# CORRESPONDENCE / MEMORANDUM

SUBJECT: SNE Engineering Report

The following are comments on the SNE Corporation report titled "Engineering Report Summarizing Site Investigation for Pentachlorophenol" by Eder Associates and dated November, 1985.

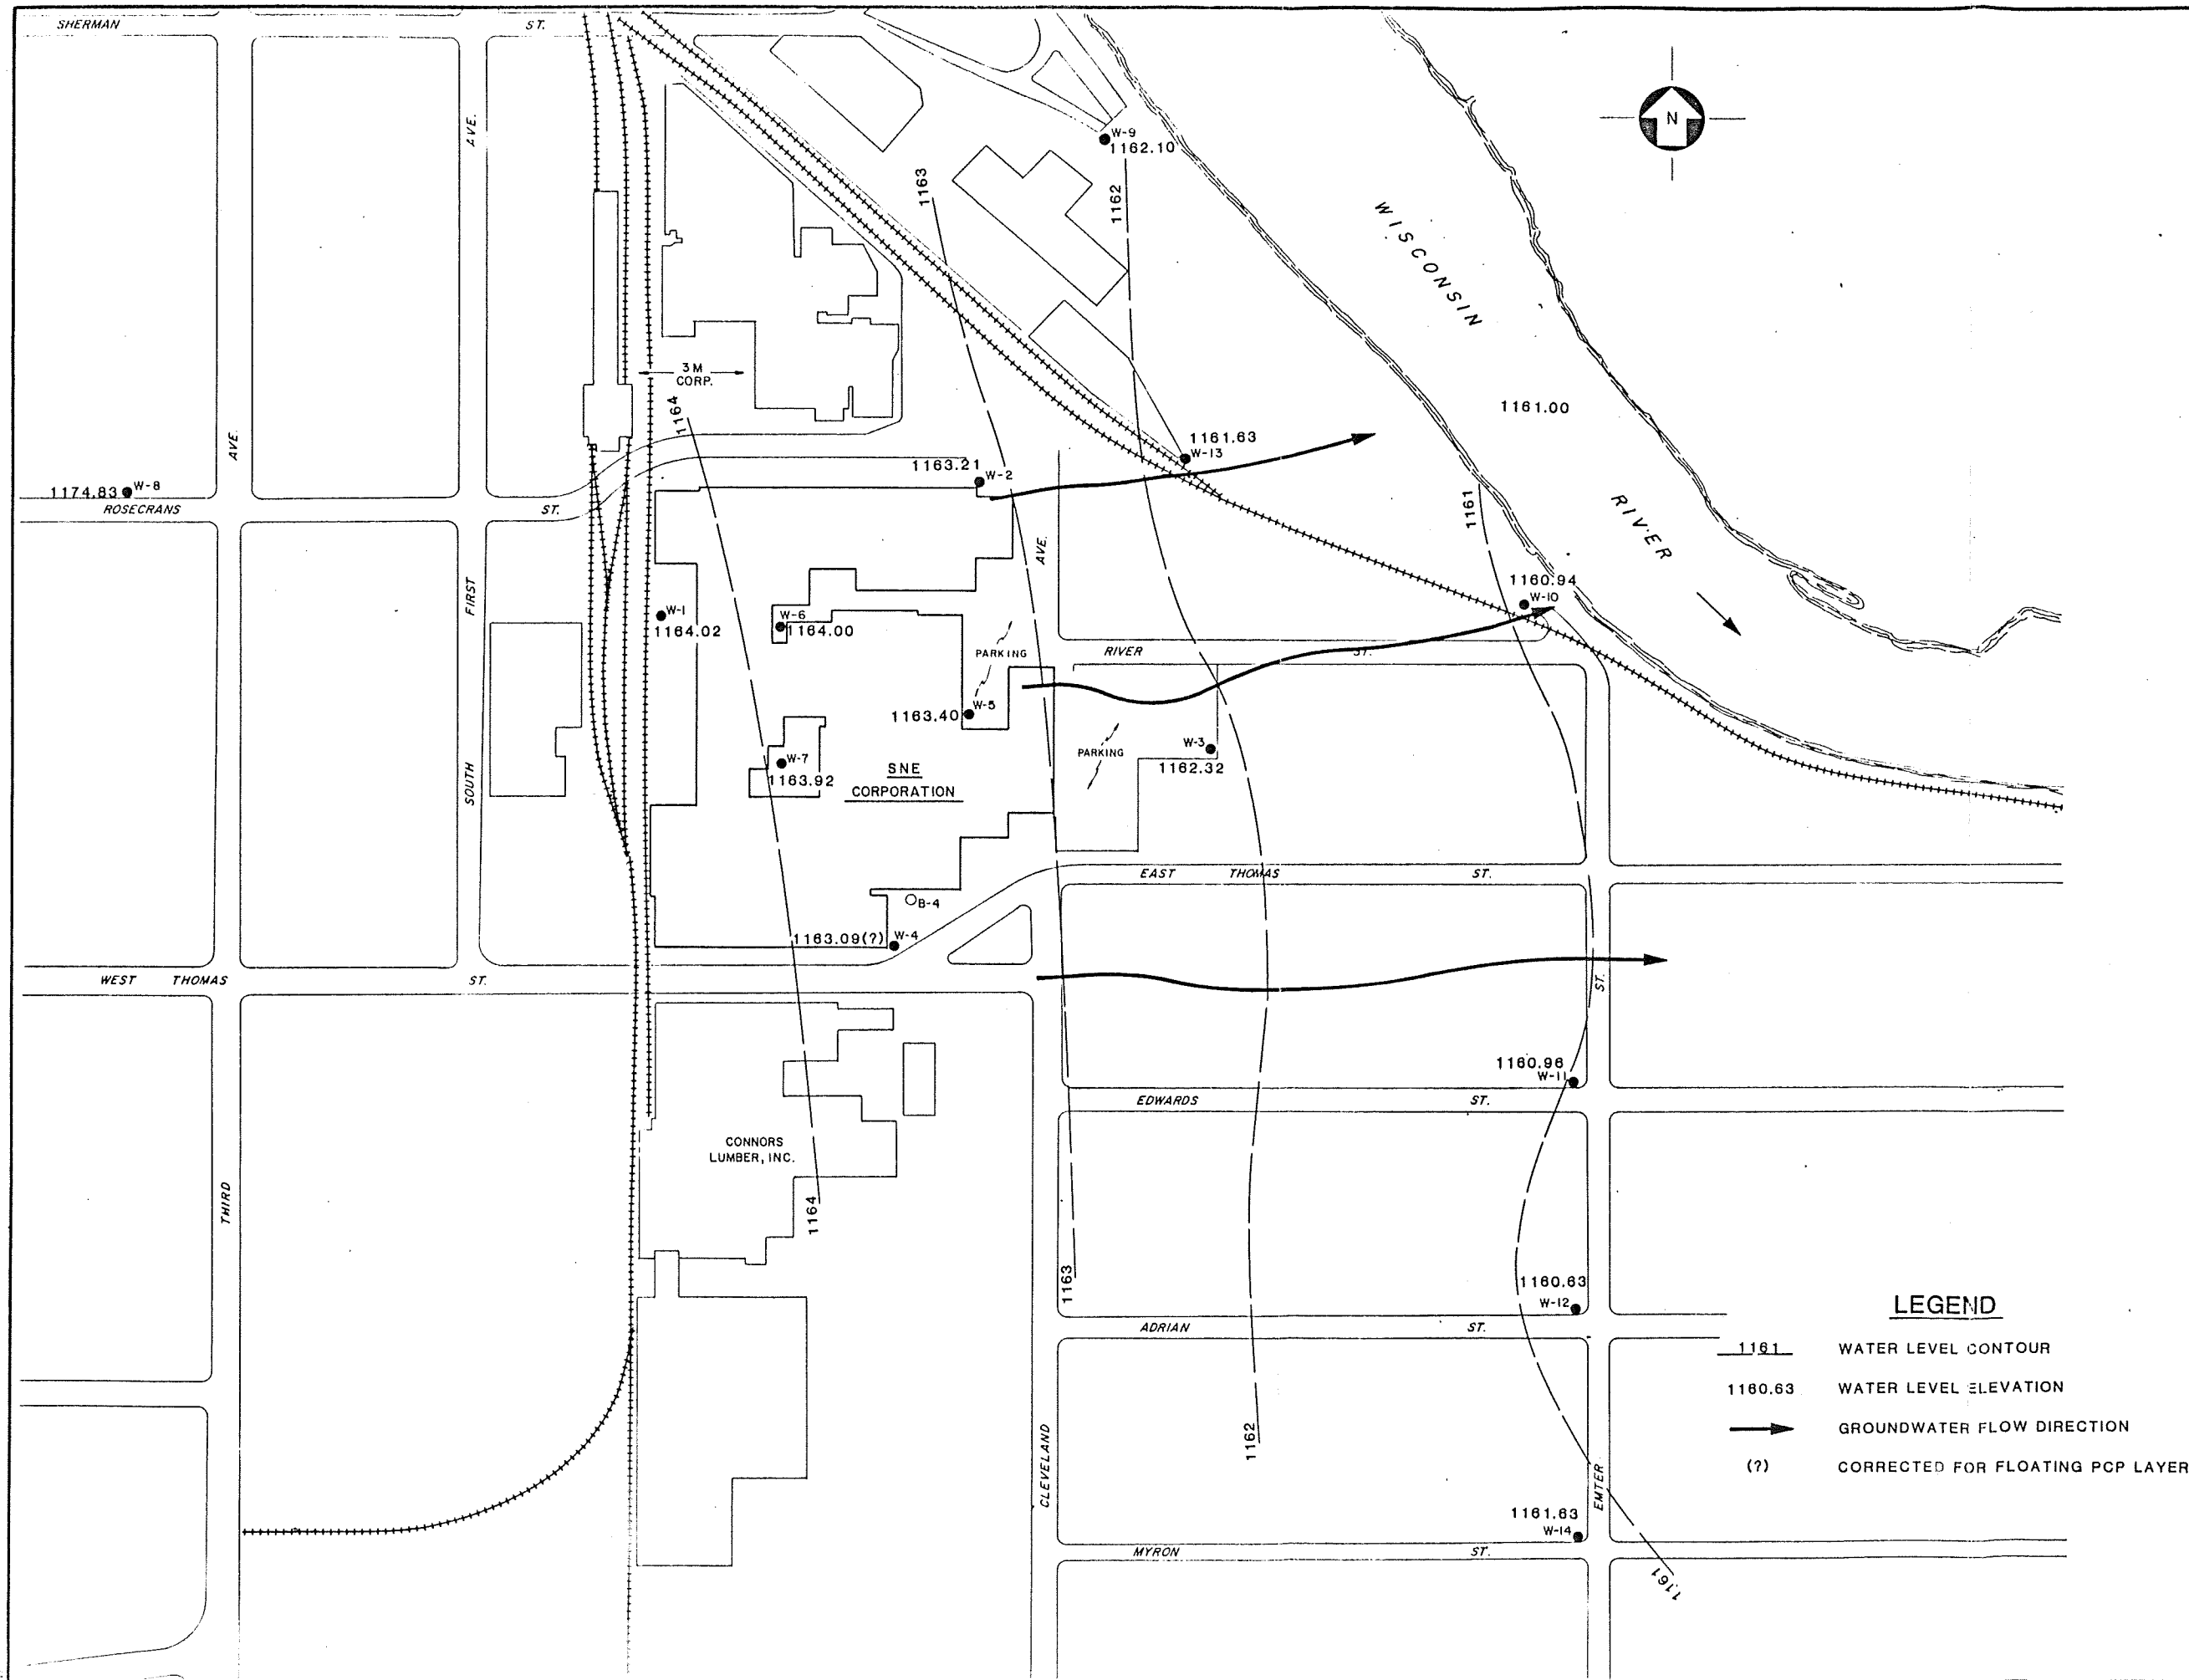
1. On page 11, the report states that there was a "possibility . . . of Penta moving in a direction other than downgradient." Yet, the 9/26/85 water table map indicates that the spread of the floating layer of PCP is consistent with the direction of groundwater flow. More permeable layers in the sand and gravel may also affect the movement of the PCP layer.

2. The report should include a discussion of how the thickness of the floating PCP layer is actually measured in the field. The 9/26/85 water table map shows water levels adjusted for the floating layer--how is the adjustment computed?
